SUBJECT: SECTION 106 CONSULTATION AND NOTIFICATION OF THE ISSUANCE AND
REQUEST FOR COMMENTS ON THE DRAFT SUPPLEMENTAL
ENVIRONMENTAL IMPACT STATEMENT FOR THE VOGTLE ELECTRIC
GENERATING PLANT, UNITS 3 AND 4 COMBINED LICENSE APPLICATION

RE: EPA Review and Comments
Draft Supplemental Environmental Impact Statement (DSEIS) for the
Combined Licenses (COLs) for Vogtle Electric Generating Plant Units 3 and 4
Construction and Operation, Application for Combined Licenses (COLs), NUREG-1947
CEQ No. 20100351

Re: Comments for the Draft Environmental Impact Statement (DEIS) for Vogtle Nuclear Plant Units 3 and 4, Application for Combined Licenses (COLs), NUREG-1947, Burke County, Georgia

Figure 3. Revised Intake Structure and Surrounding Wetlands (Southern 2010b)

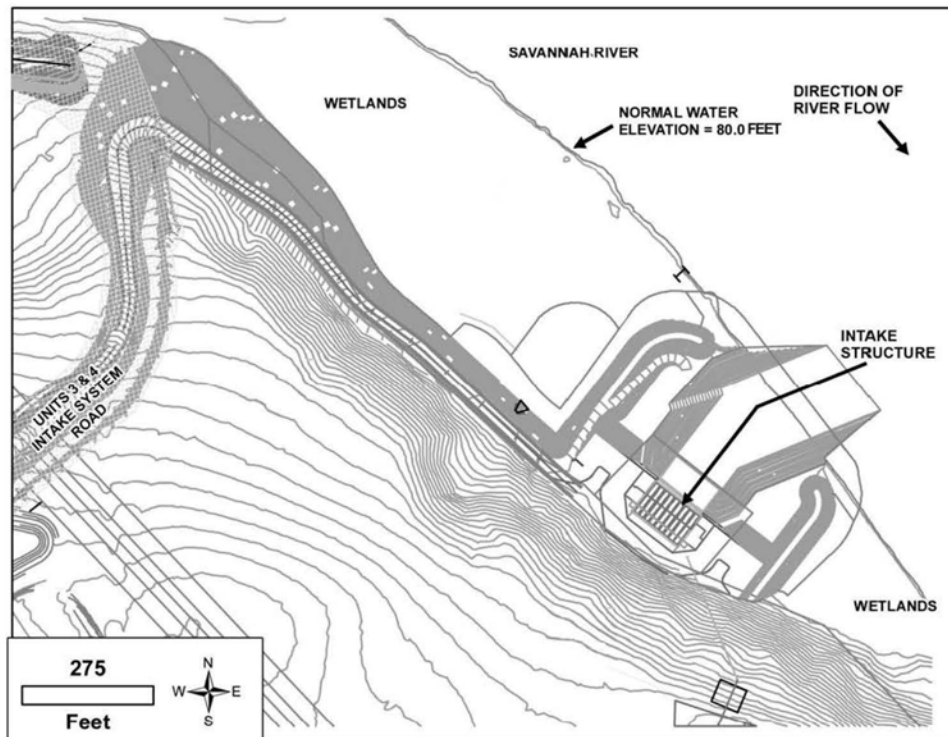
The design and location of the cooling water intake structure for proposed Units 3 and 4 has changed since the original BA was sent to NMFS in January 2008. The cooling water intake structure has been repositioned upstream approximately 46 m (150 ft), which places it approximately 650 m (2130 ft) upstream of the existing intakes for Units 1 and 2 and approximately 427 m (1400 ft) downstream of the outlet to the unnamed tributary of Mallard Pond. Southern also described a change in the dimensions of the intake structure (Southern 2010b); this change will lower the intake structure floor from elevation 38.1 m to 32.0 m (125 to 105 ft). In addition, there will be a slight bend (i.e., approximately 30 degrees) about halfway down the canal to orient the mouth of the intake canal perpendicular to the river. Figure 3 illustrates the revised intake structure and the wetlands in its vicinity. The design changes (Southern 2010b) do not substantially modify the width of the intake canal or the length of the canal extending beyond the existing river bank. The new location and design modifications did not alter the basis for the NRC staff's analysis of construction impacts in the COL SEIS.

Although the design and location of the cooling water intake structure has changed, the orientation of the mouth of the intake canal in relation to the river (perpendicular) has not changed. There is a slight bend in the intake canal (approximately 30 degrees) as shown in Figure 3; however, the orientation of the mouth of the intake canal relative to the river will not change. The new location of the intake canal is in habitat similar to that in the previous location (i.e., on a straight portion of the river and in the same floodplain.) No changes were made to the water withdrawal rates, through-screen velocities, traveling screen mesh size, or the hydraulic zone of influence, which are the main factors that would impact entrainment or impingement rates of aquatic biota during operation of the cooling water intake structure (Southern 2010b).
